HORSHAM DISTRICT COUNCIL CONSULTATION

TO:	Horsham District Council – Planning Dept
LOCATION:	New Place Nurseries London Road Pulborough West Sussex
DESCRIPTION:	Approval of details reserved by conditions 2 (site levels) and 4 (roadway details by plots 20-26) to approved application DC/24/1676
REFERENCE:	DISC/26/0266
RECOMMENDATION:	Condition 2: Modification / More Information Condition 4: Modification

d. Substation

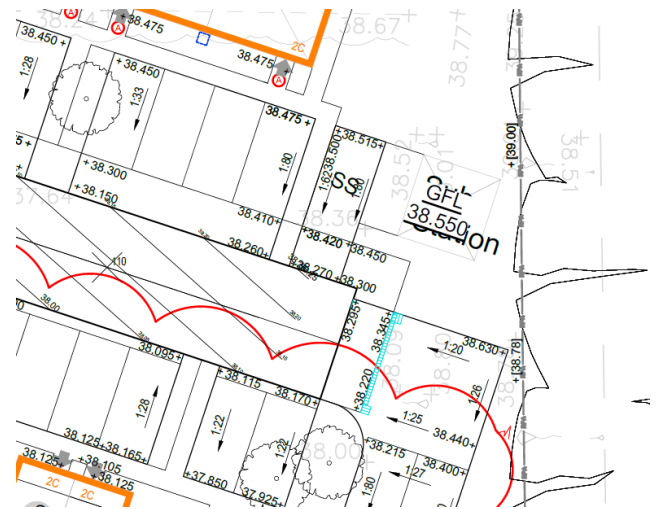
4. While some concerns raised under DC/24/1676 have been addressed, the submitted levels strategy continues to include steep gradients with no stabilisation methods proposed that raise concerns regarding landscape integration, maintenance of the landscape scheme and user safety. Gradients must be reduced where feasible to minimise the use of engineered interventions such as safety railings at a later stage. Where these cannot be avoided, stabilisation measures, retaining structures and any safety features should be provided. Such measures should be informed by a safety audit where necessary. Where turf is proposed, gradients should not exceed 1:3 to facilitate required maintenance. Please see non-exhaustive examples below:
